**DEVIATION REVIEW
 AND DECISION FORM**

Subdivision or Project Name: Homestead at SR Filing No. 2

**DEVIATION REQUEST EXHIBIT HOMESTEAD AT SR FILING NO.2
 ECM 3.3.1.J.8 EXCEEDING MAXIMUM VELOCITY 18 FPS**

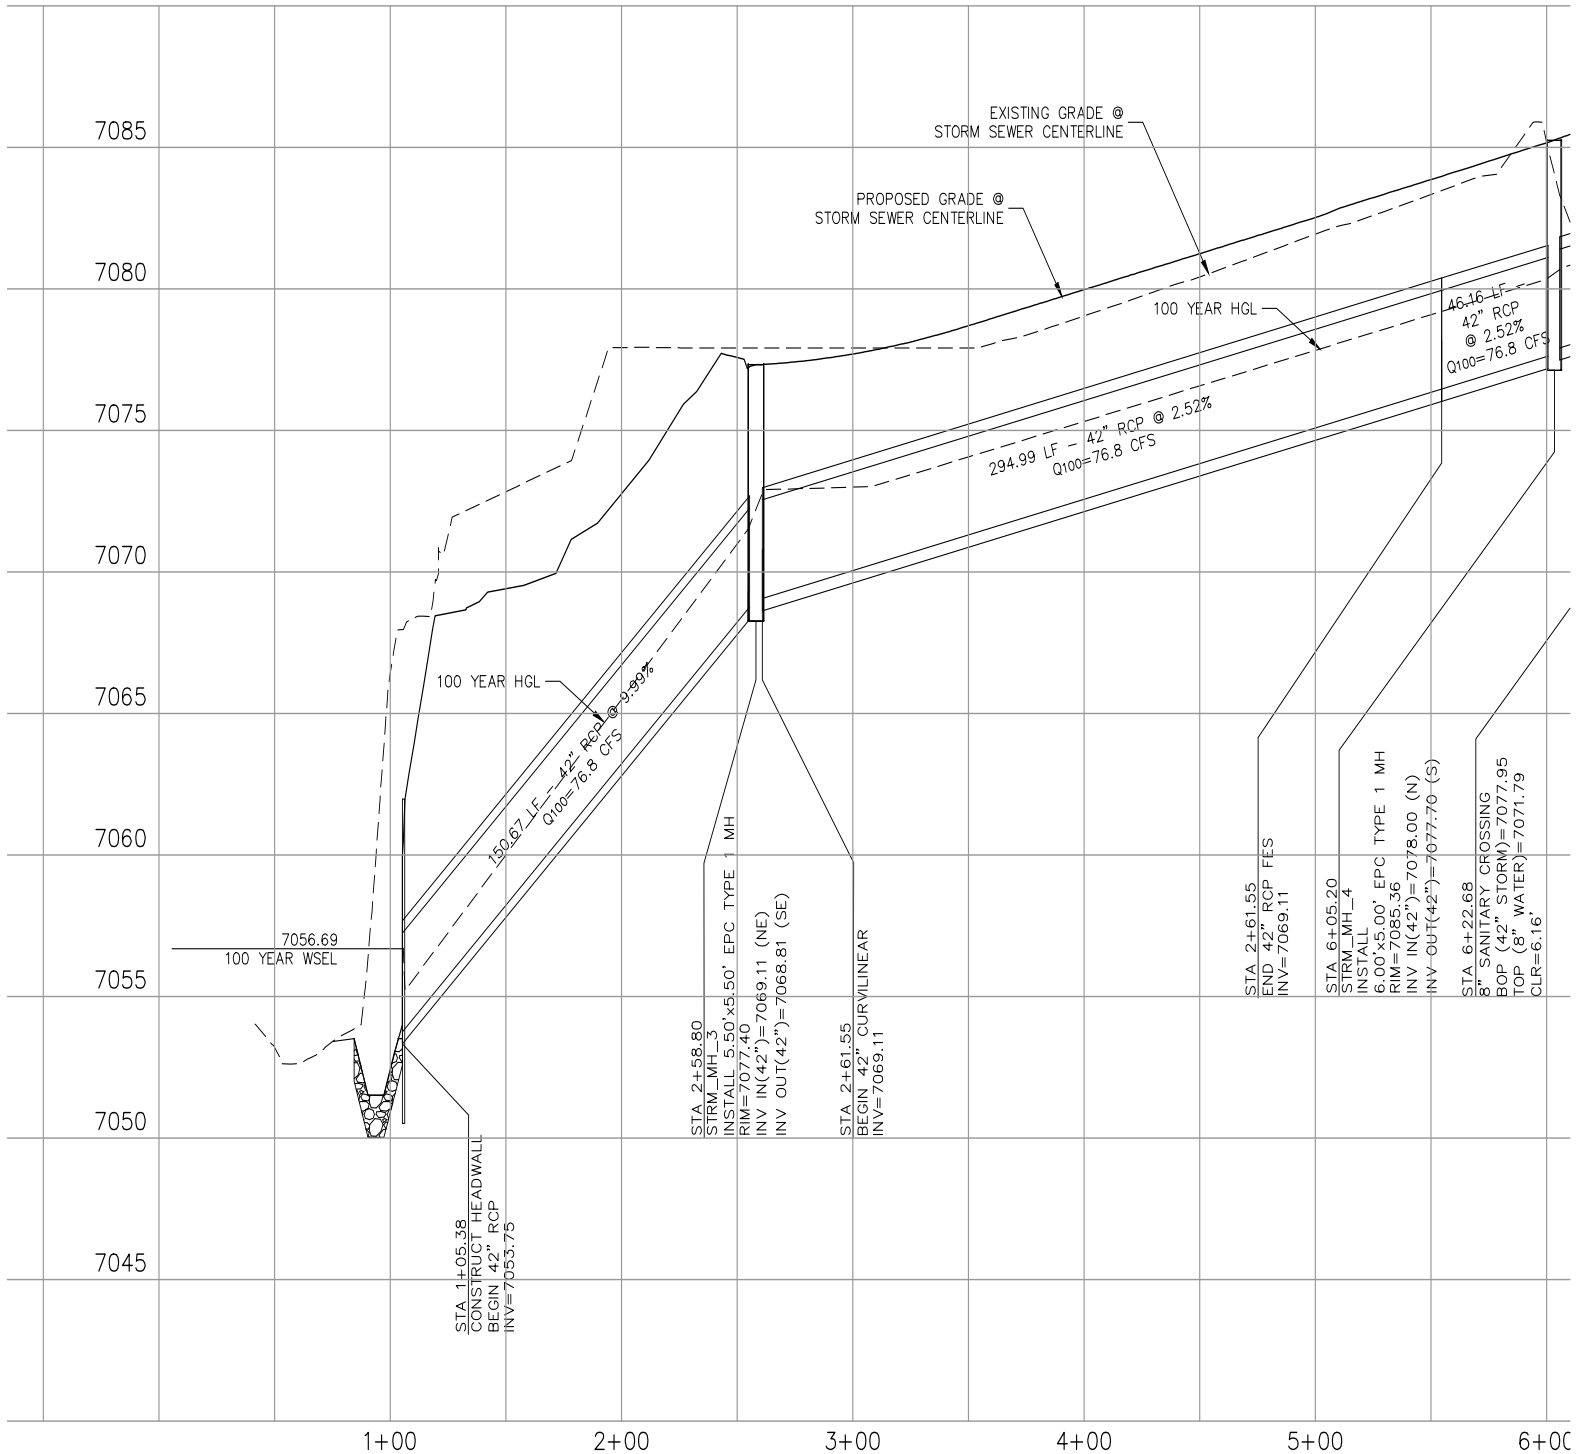
Address the outfall design. What can be done to reduce velocities at the outfall?
